**Comanche Peak Nuclear Power Plant, Units 3 & 4
COL Application**

**Part 3,
Environmental Report
Update Tracking Report**

Revision 5

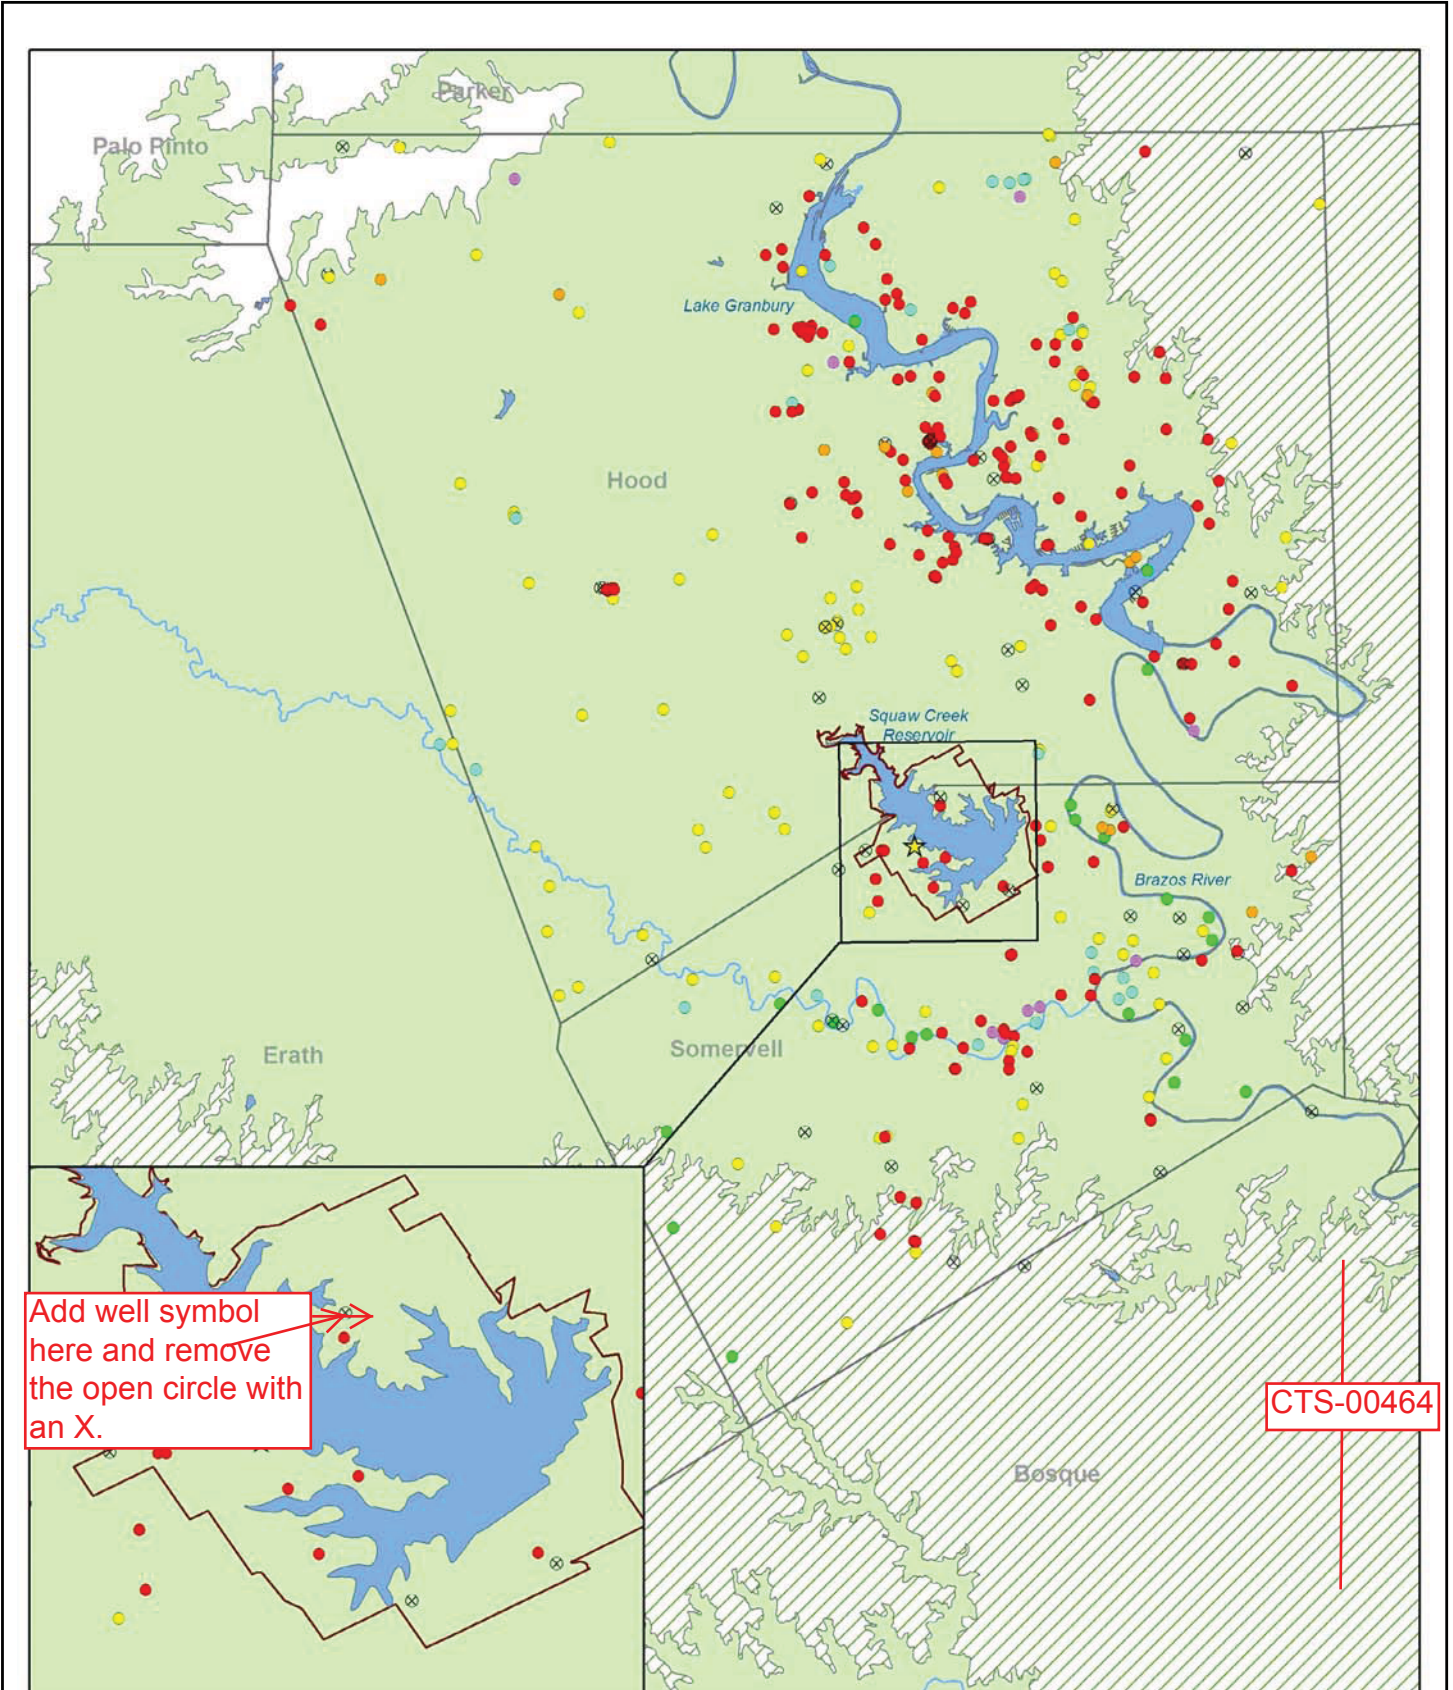
Northing	Easting	
UNIT3:	613759 <u>3574606</u>	3574606 <u>613759</u>	CTS-00716
UNIT4:	613453 <u>3574559</u>	3574559 <u>613453</u>	CTS-00716

The center point of the CPNPP Units 3 and 4 site is located at ~~613606~~3574584N and ~~3574584~~613606E. | CTS-00716

COMANCHE PEAK NUCLEAR POWER PLANT
UNITS 3 AND 4
 Intake and Discharge Locations
 FIGURE 3.4-3 (Sheet 3 of 3) Rev 0

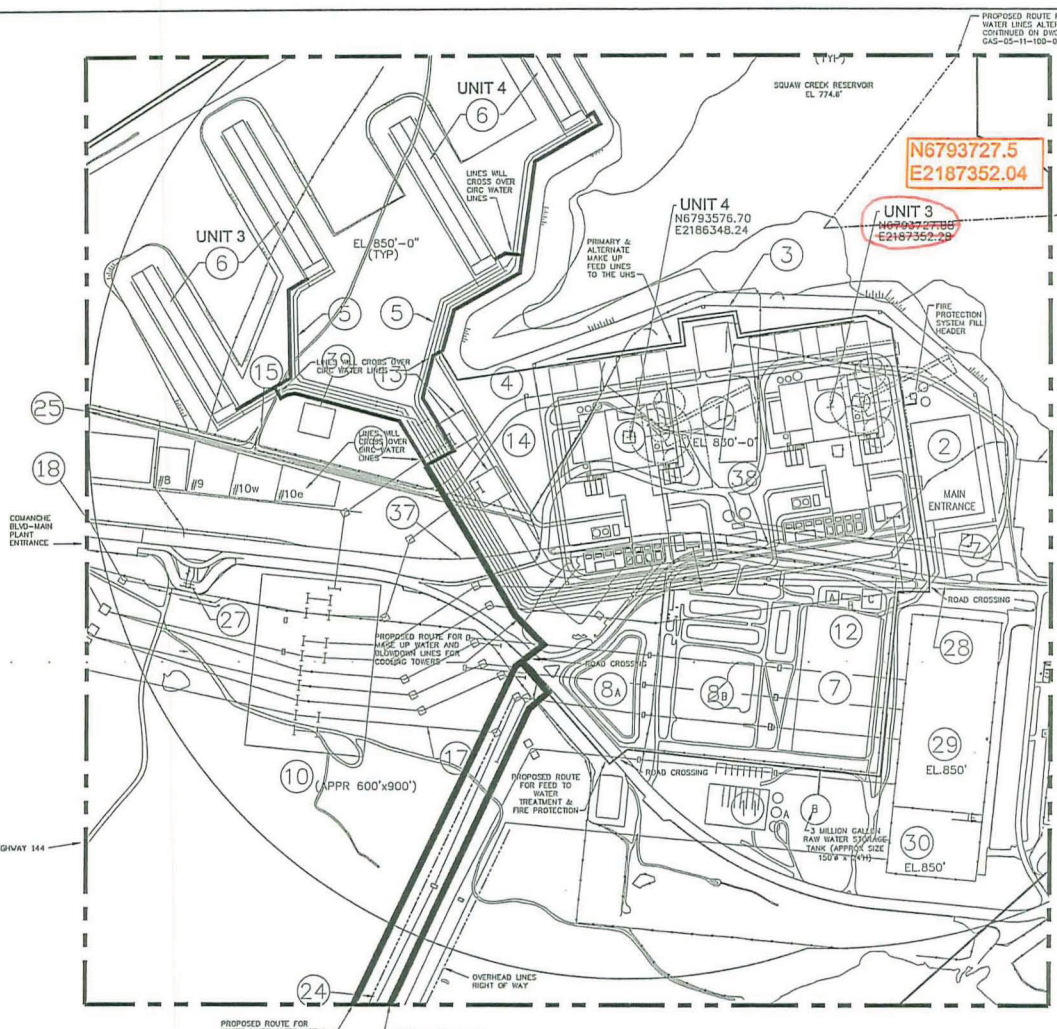
CTS-00842

PIPE DISTANCES
 SEE DWG GAS-05-11-100-03 FOR MAKE UP WATER AND BLOWDOWN PIPE DISTANCES.
 PIPE ON THIS DRAWING -
 -FIRE PROTECTION SYSTEM FILL - 2500 FT
 -FEED TO UHS - PRIMARY - 2300 FT
 -FEED TO UHS - ALTERNATE - 2500 FT
 -FEED TO NEW WATER TREATMENT FAC. - 1700 FT
